Entergy Operations, Inc.
1448 S.R. 333
Russellville, AR 72802
Tel 501 858 5000

2CAN120106

Subject: Arkansas Nuclear One - Unit 2
Docket No. 50-368
License No. NPF-6
Corrections to the ANO-2 Power Uprate License Application

Corrections to License, Technical Specifications and COLR Pages

FIGURE 2

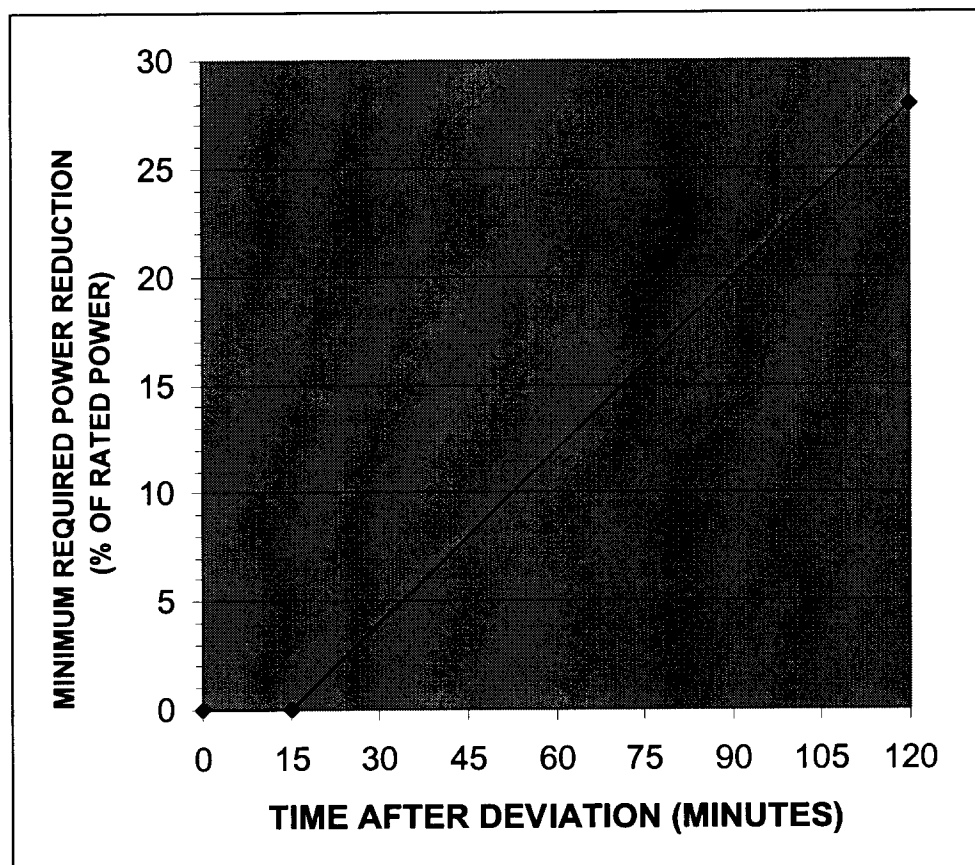
The phrase WITH BOTH CEACs INOPERABLE was inadvertently added to the end of the title. The only change to the title was intended to be insertion of the word INWARD between AFTER and CEA. The title should read REQUIRED POWER REDUCTION AFTER INWARD CEA DEVIATION. The title has been corrected.

Existing Figure 2 of the Cycle 15 COLR will be replaced with the following figure:

REQUIRED POWER REDUCTION AFTER INWARD CEA DEVIATION *
